MEMORANDUM

Re: Binyomin Amona, dba BAMA Enterprises, Two Lots, each with a Two-Family Home
619 Union Road
SBL# 50.05-1-18

Date: January 23, 2025

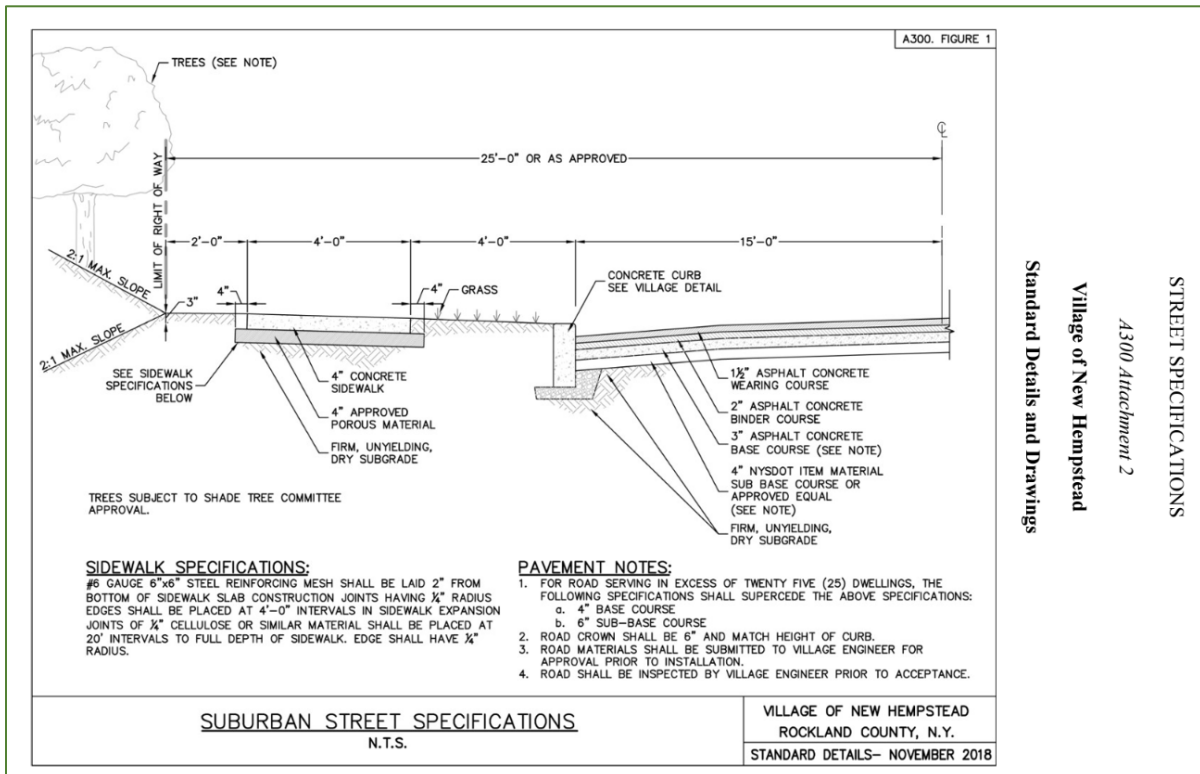
1. **Only 30 feet of street frontage is provided for the rear lot.** Per the Table of Dimensional Requirements in §290 Attachment 2, in the 2R-15 District, one hundred twenty-five (125) feet of Frontage on a street meeting Village Standards is required for the rear lot.

New lots in this district are required to have 125 feet of frontage on either an existing street, or a new street created to Village standards. Rather than providing a new street for Lot 2 to gain frontage, only a 12-foot driveway is shown. The minimum standards for a Village Street in 2R-15 are as follows, per §255-32.H Streets and §A300 Street Specifications: See §A.300 figure 1 and §255-31.H for Village Road standards for requirements.

- a. A 50’ foot Right of Way containing a frontage street is required for lot 2 is required. Instead, a flag lot is provided, that is not allowed by the zoning or subdivision code chapters. See §A.300 figure 1, Suburban Street Specification.
- b. Thirty (30) feet of travel way is required, curb to curb, as a minimum pavement width of a street giving frontage to a lot. Only 12 feet of driveway width is shown. The driveway is set 2 feet from the side property line.
- c. A cul-de-sac with a 100-foot diameter pavement, within a 120-foot diameter right-of-way is required at the end of any dead-end street. No cul-de-sac is provided. See 255-31.E and H.

See below for an illustration of the required street standards from the Village Code.

A street conforming to Village standards should be designed for this project. If a Village Street with a cul-de-sac is created, per footnote 2 of 290 Attachment 2:4, the Table of Dimensional Requirements, the minimum lot frontage on a cul-de-sac may be reduced, but the granting of such a waiver would be at the Planning Board's discretion.
